**PREVOST**ENREGISTRÉ - REGISTERED
ISO 9001 & ISO 14001**WARRANTY
BULLETIN**

Wb08-03

| SUBJECT : REPROGRAMMING THE ELECTRONIC STABILITY PROGRAM (ESP) SOFTWARE | | |

Electronic Stability Program

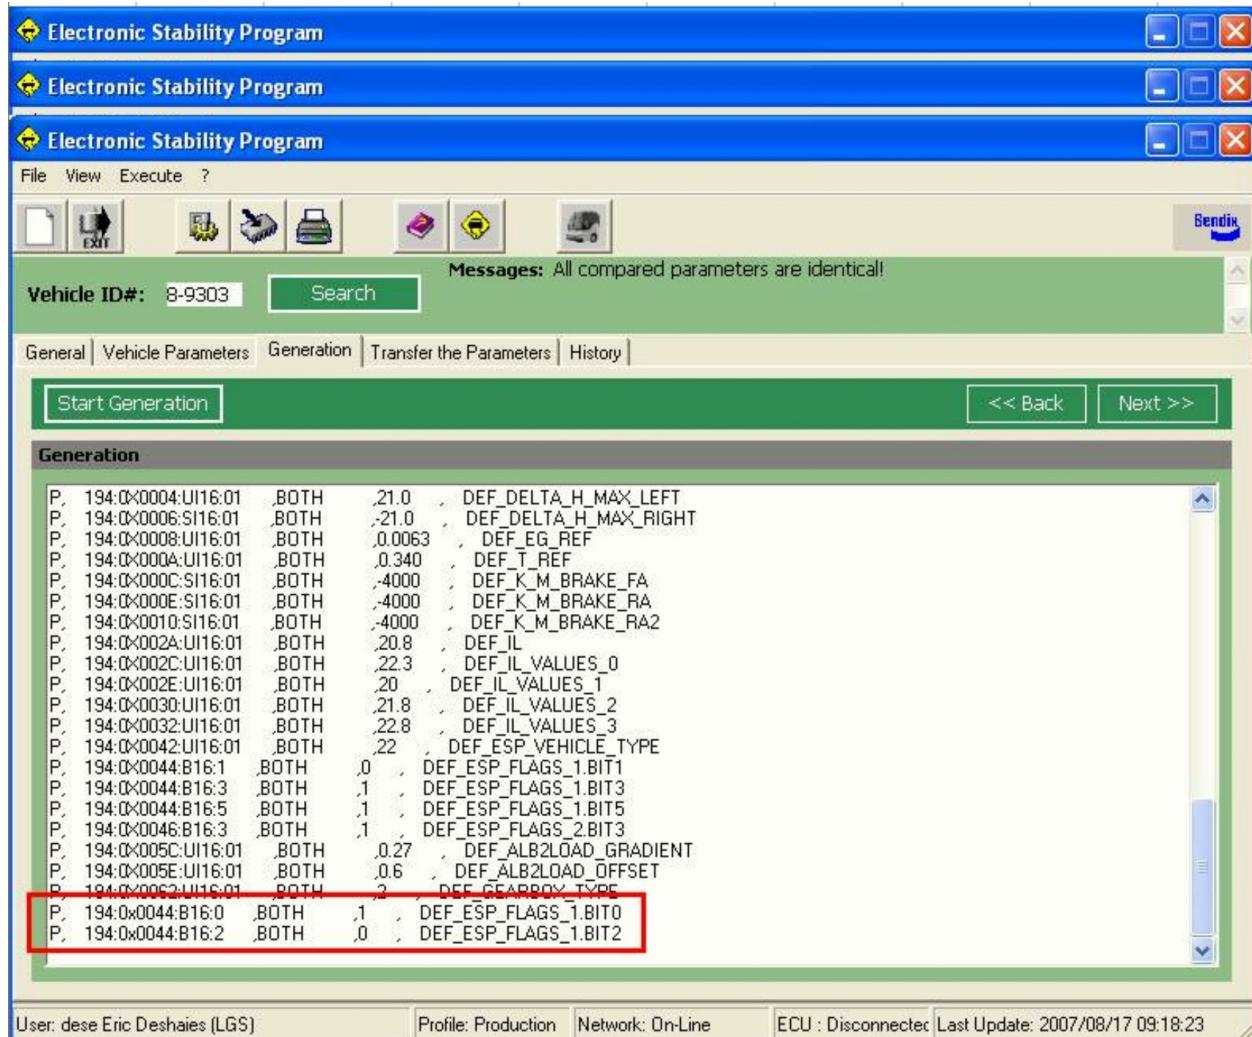
It has come to the attention of Prevost that on the above-mentioned vehicles equipped with the Automatic Traction Control (ATC) feature and Electronic Stability Program (ESP), there is a possibility that the dashboard telltale light  remains illuminated if the "direction of movement" parameters for the steering column sensor and lateral acceleration sensor were not specified during programming.

To prevent this situation from happening, we strongly recommend that you make an appointment with your Prevost Service Center or that you contact your Regional Service Manager to reprogram the Electronic Stability Program (ESP) software.

Messages: RECOMMENDATION: Generate and Transfer the parameters!
Vehicle generic template has changed since last generation!
Parameter(s) have been added or deleted!
